Addendum NO. 1

(Issued April 1st, 2024)

Bid No. 22151 (“Project” or “Contract”)
Urban Promise Academy – Portable Relocation Project
3031 E 18th Street, Oakland CA 94601

C1.00

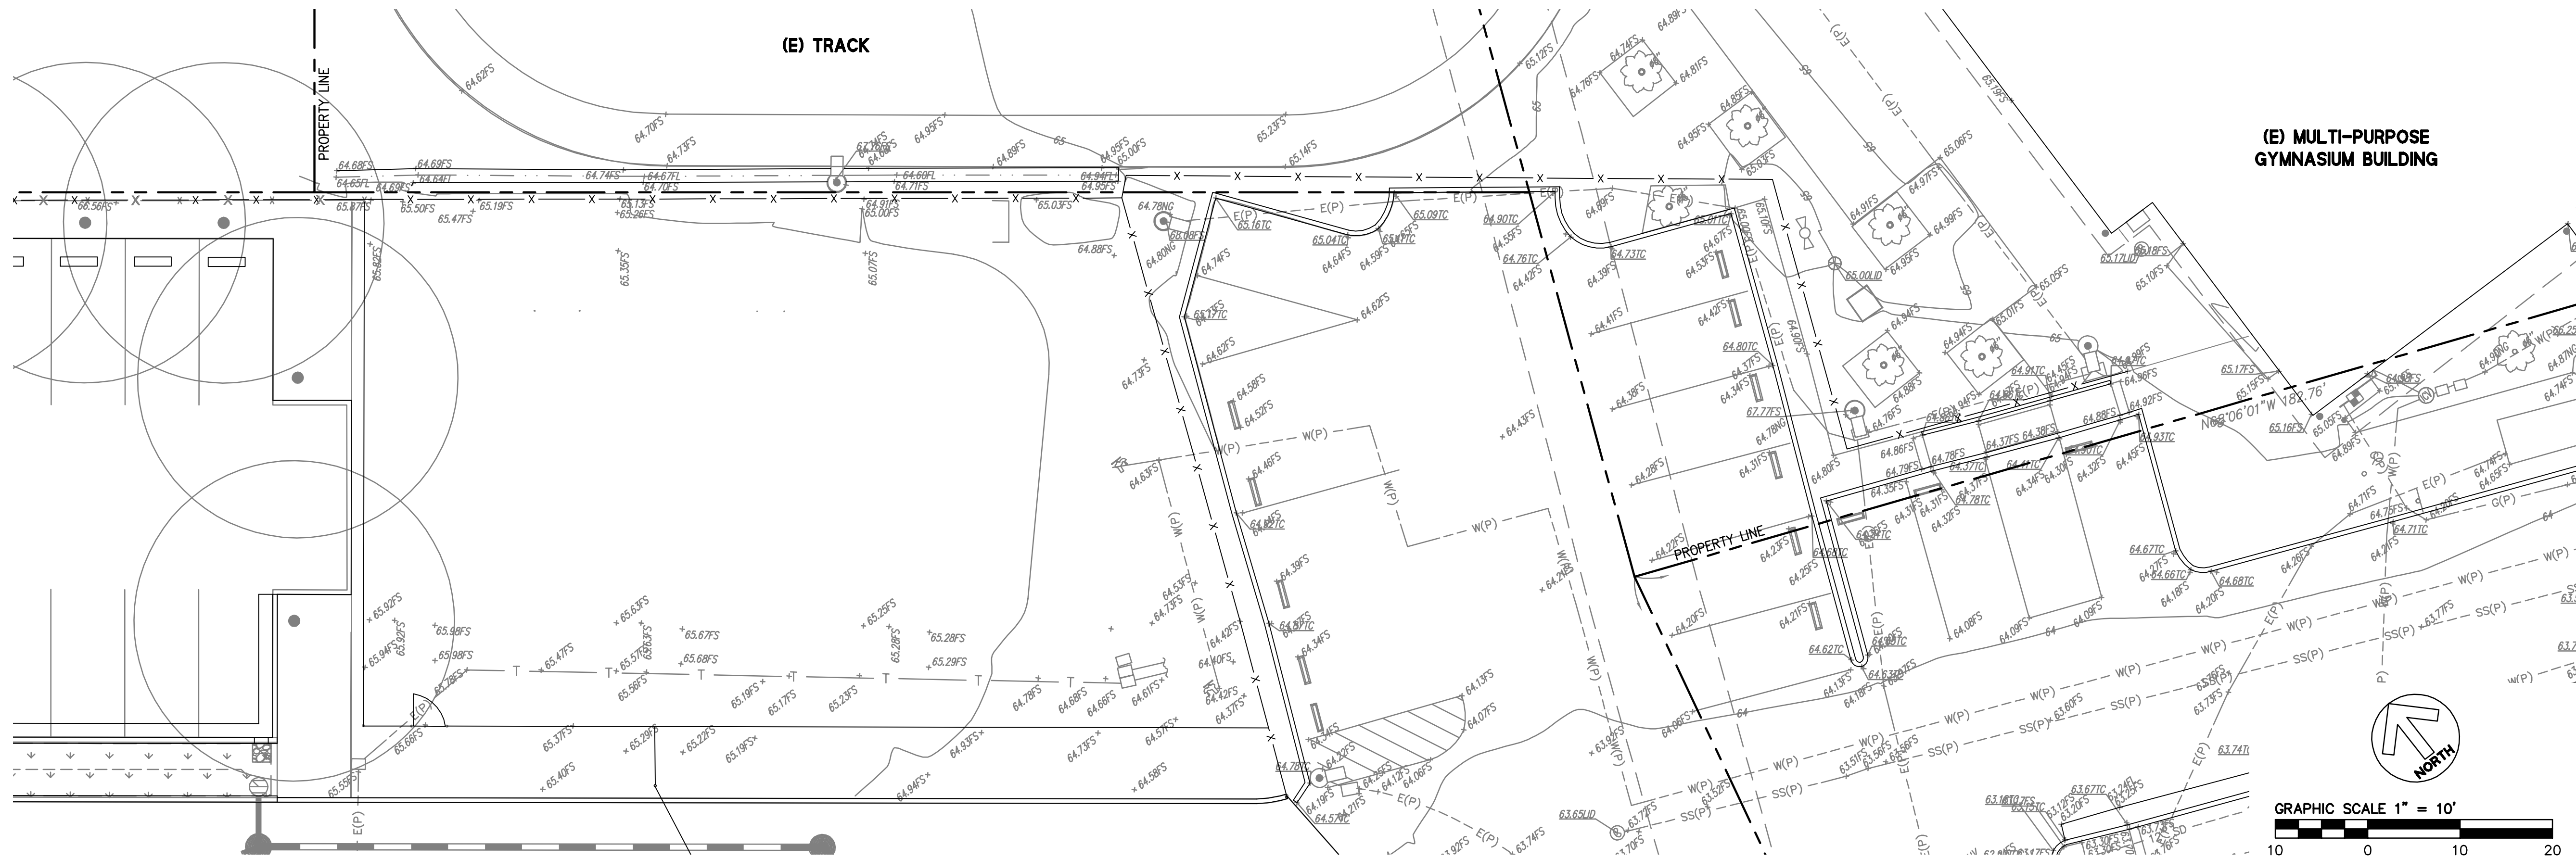
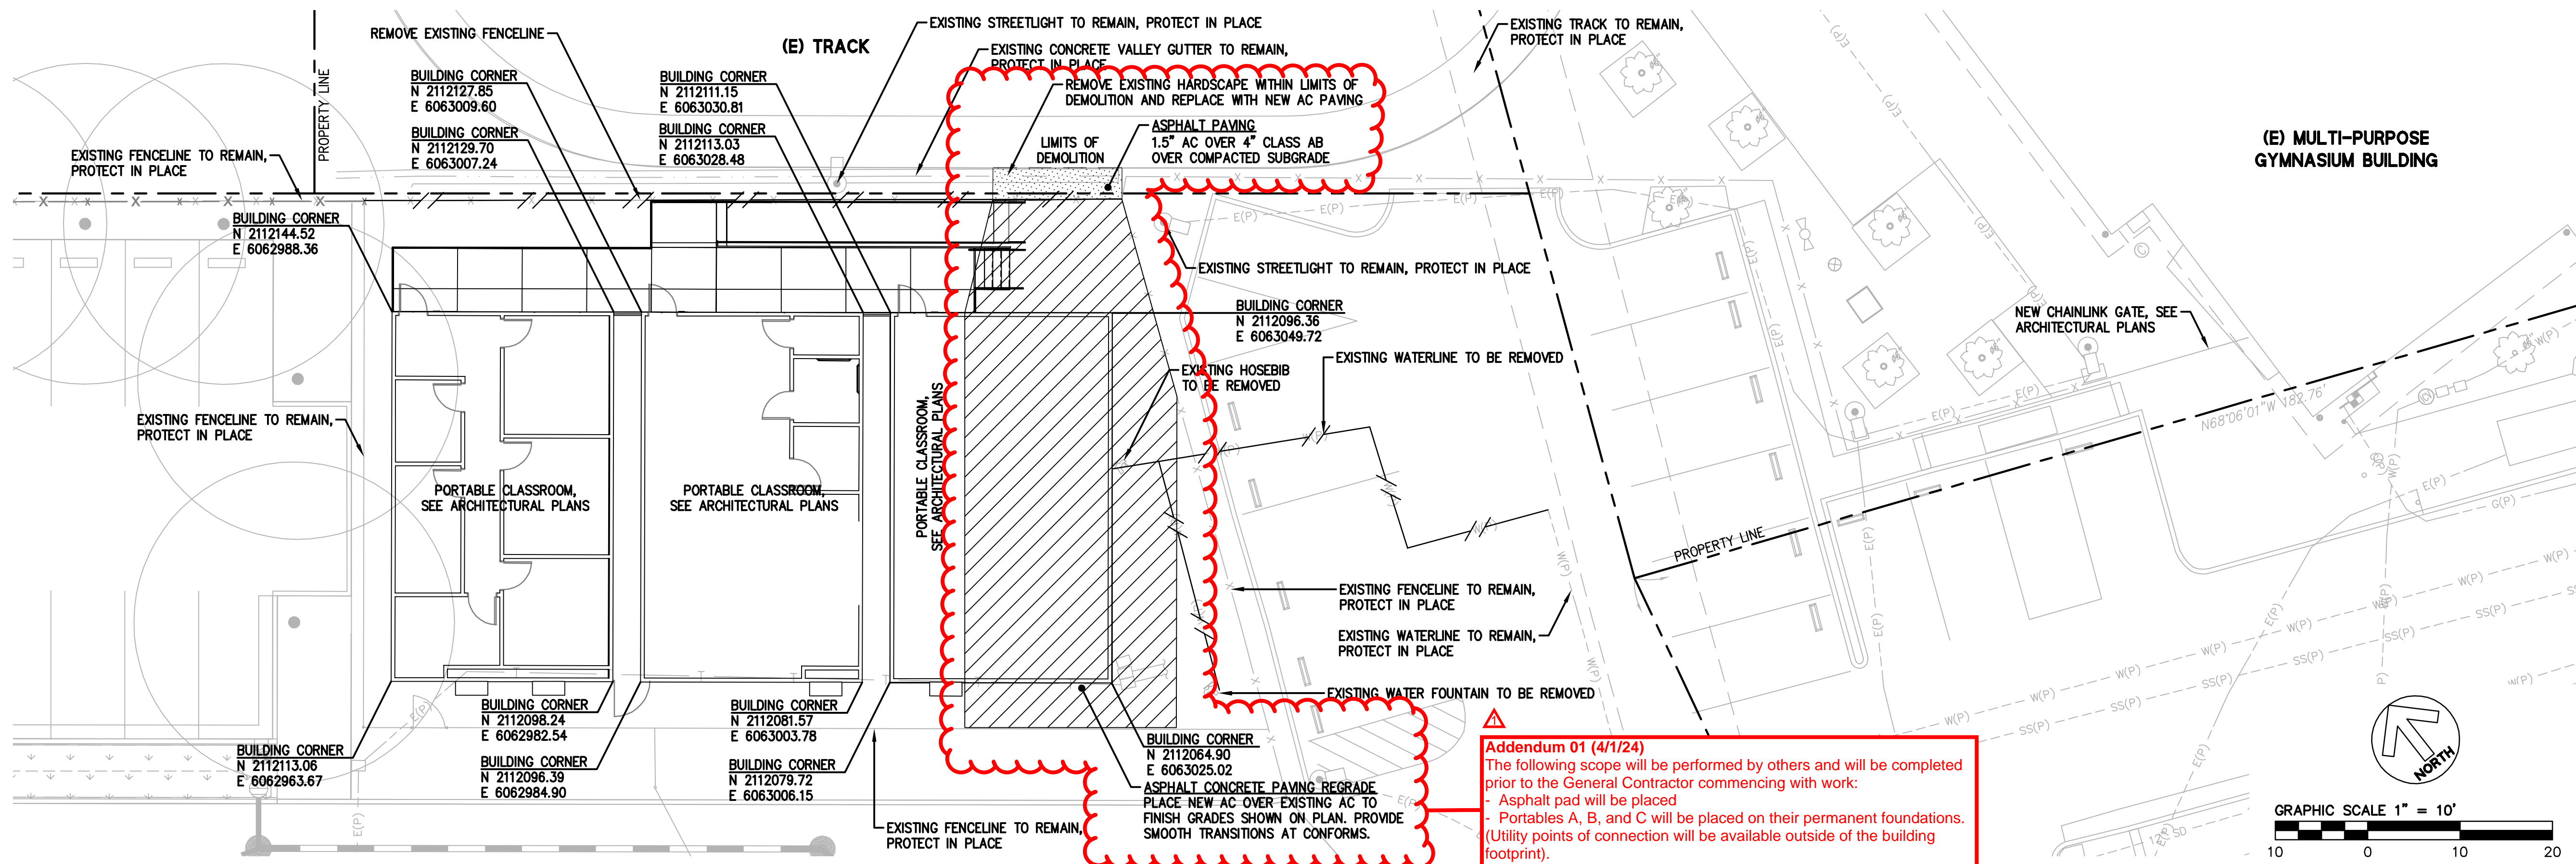
▲ Addendum 01 (4/1/24)
 The following scope will be performed by others and will be completed prior to the General Contractor commencing with work:
 - Asphalt pad will be placed
 - Portables A, B, and C will be placed on their permanent foundations. (Utility points of connection will be available outside of the building footprint)
 All other work is the responsibility of the General Contractor

A1.00

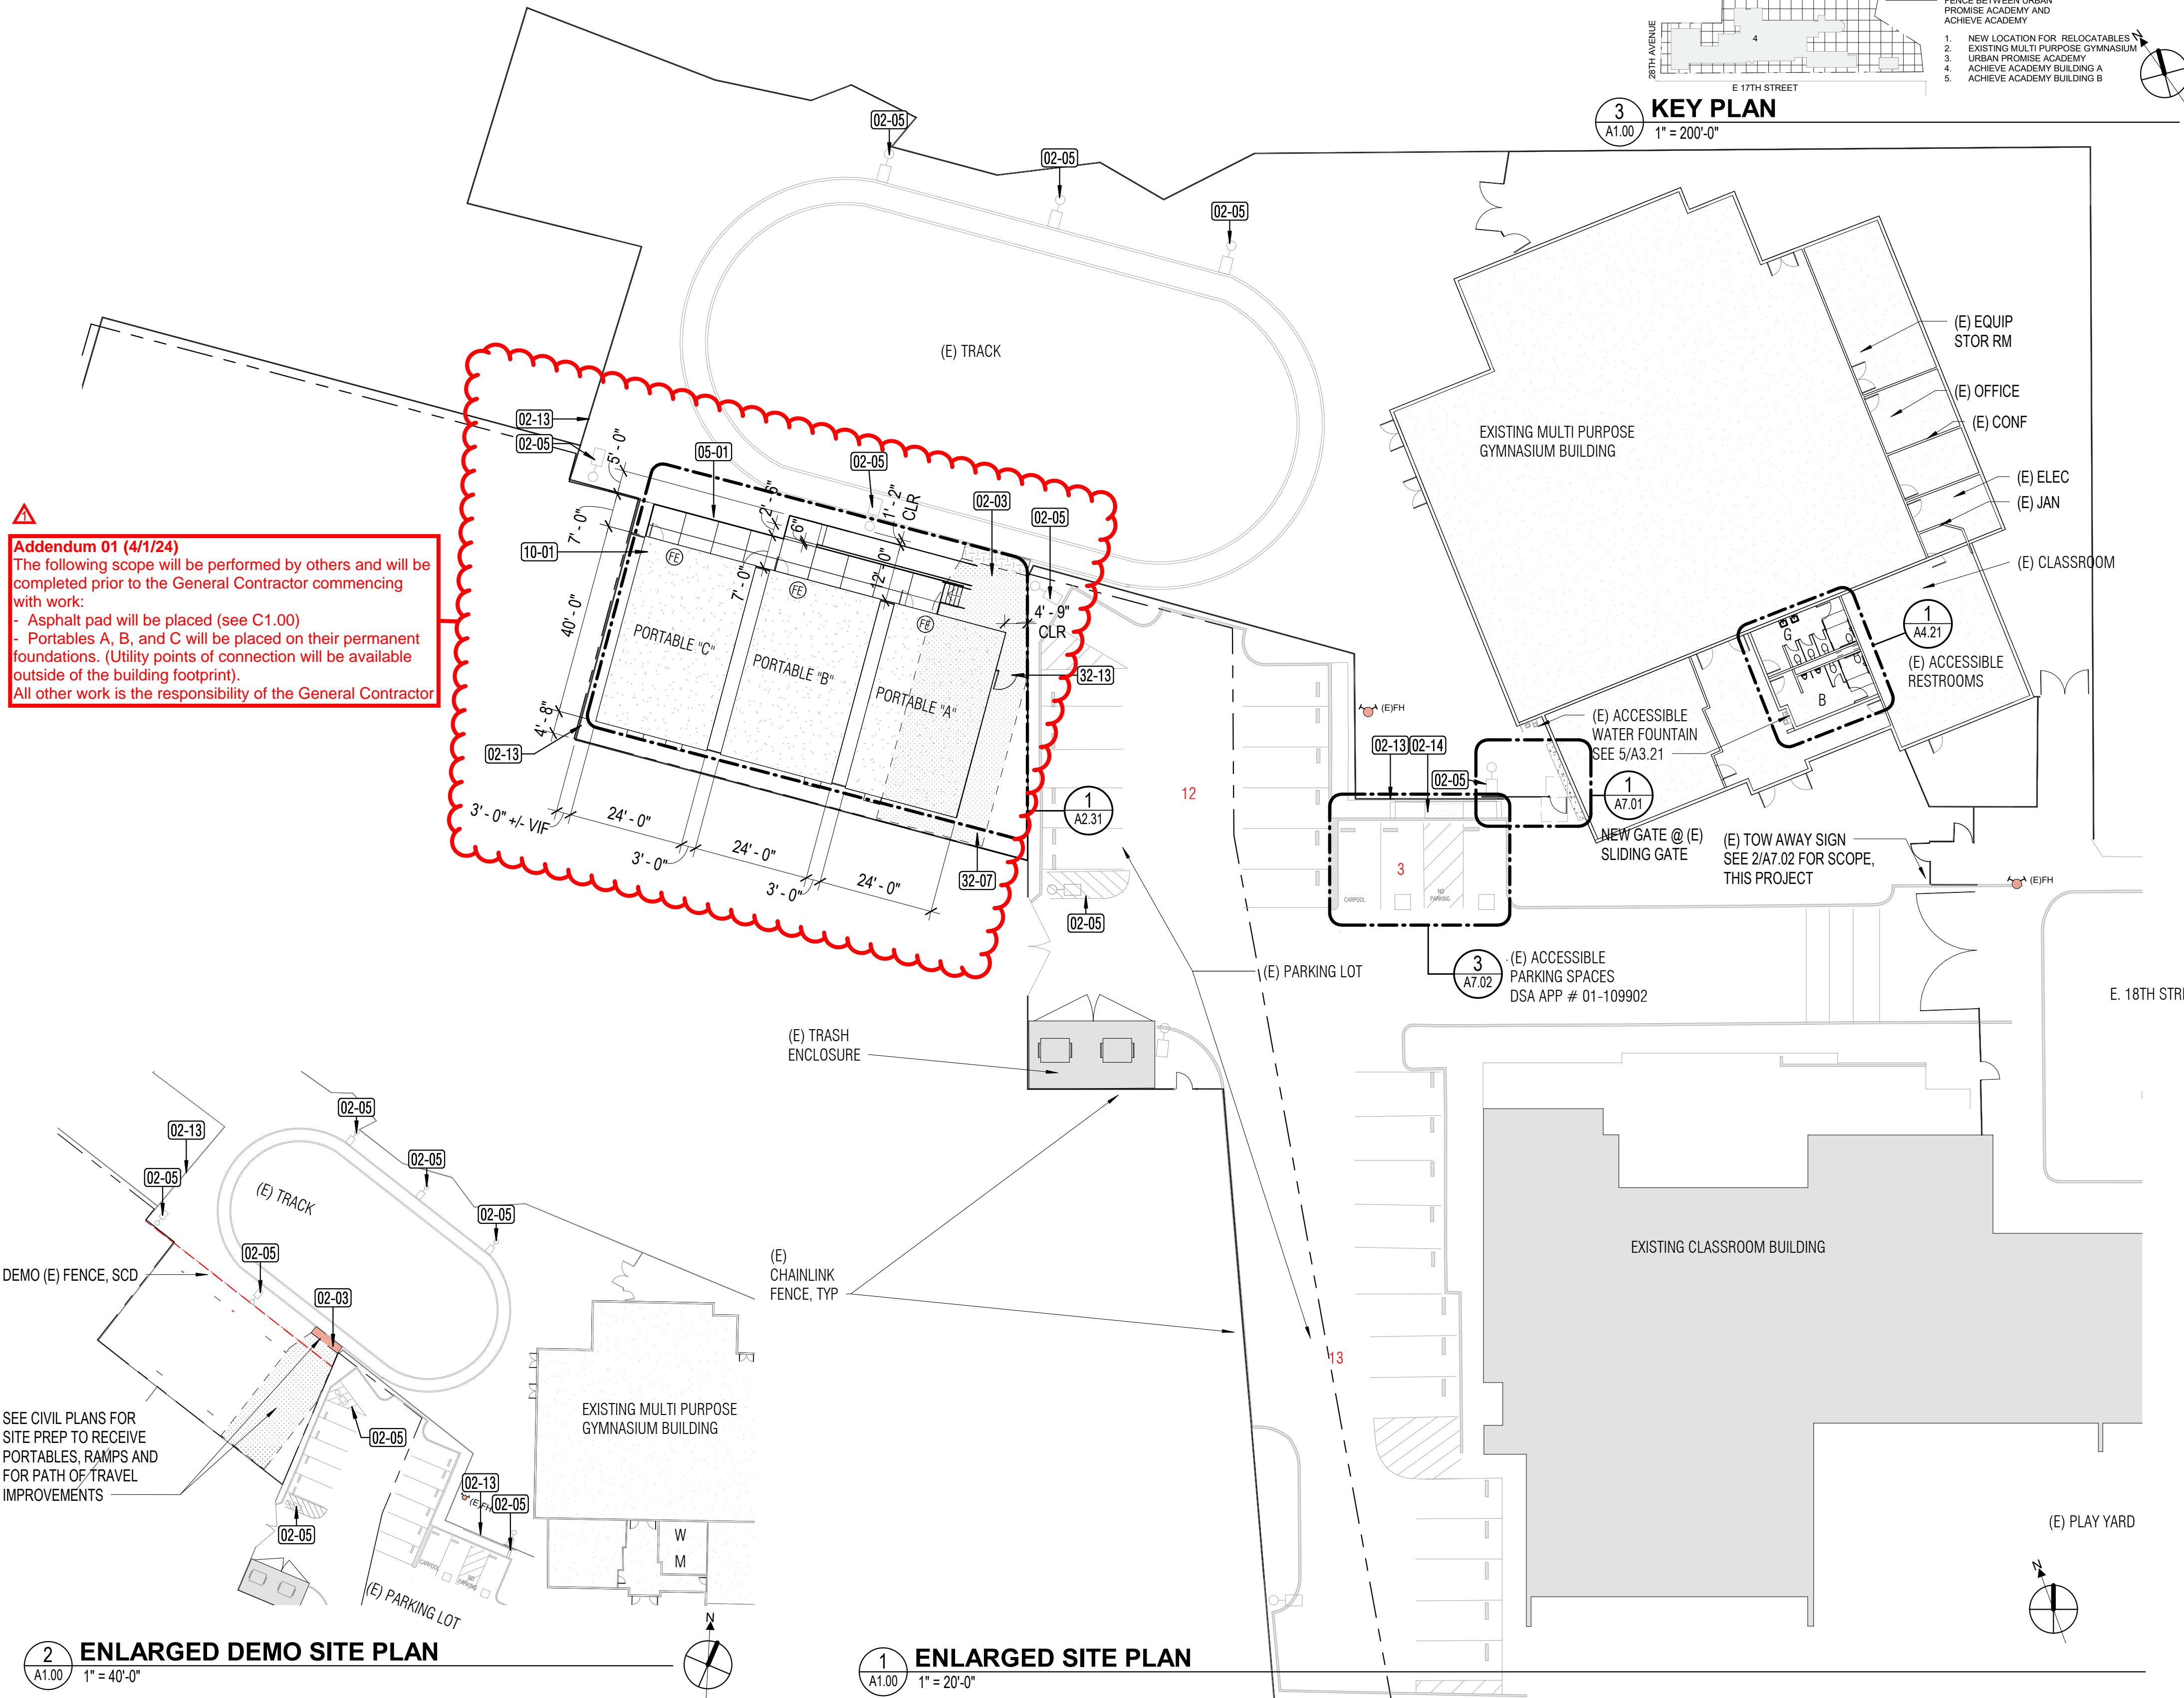
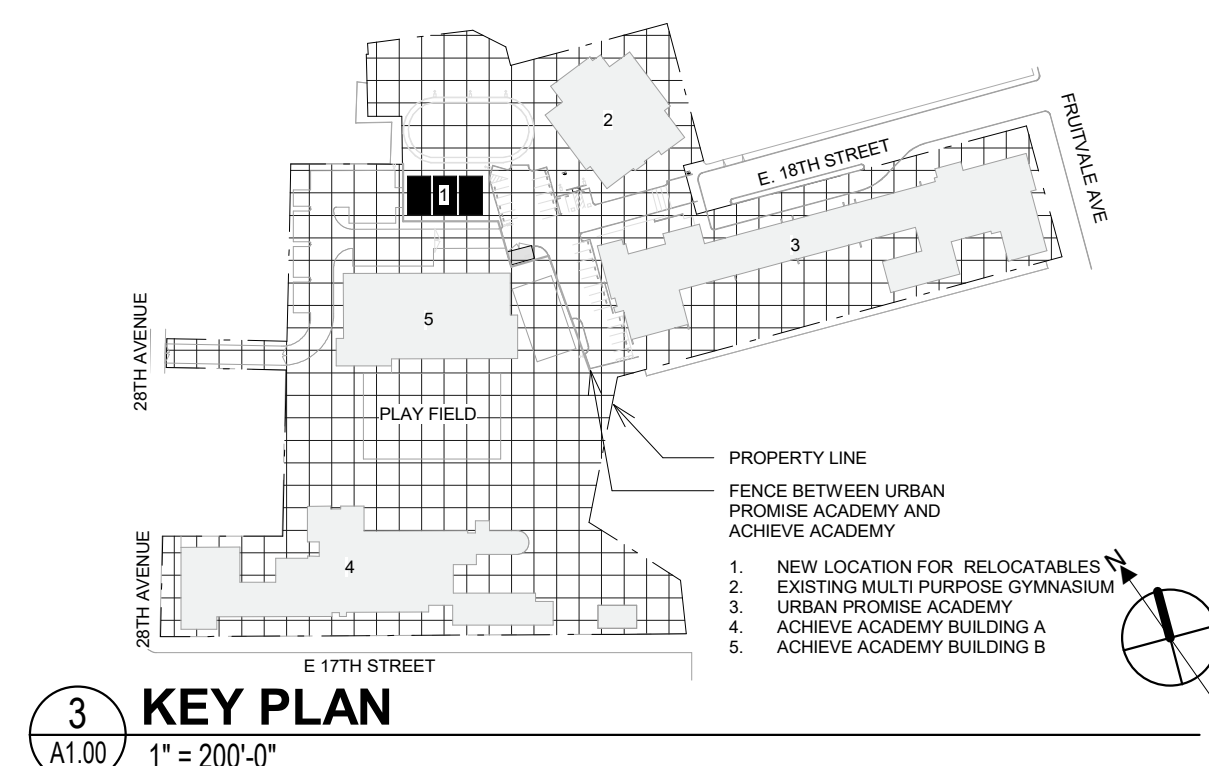
Addendum 01 (4/1/24)
 The following scope will be performed by others and will be completed prior to the General Contractor commencing with work:
 - Asphalt pad will be placed (see C1.00)
 - Portables A, B, and C will be placed on their permanent foundations. (Utility points of connection will be available outside of the building footprint).
 All other work is the responsibility of the General Contractor
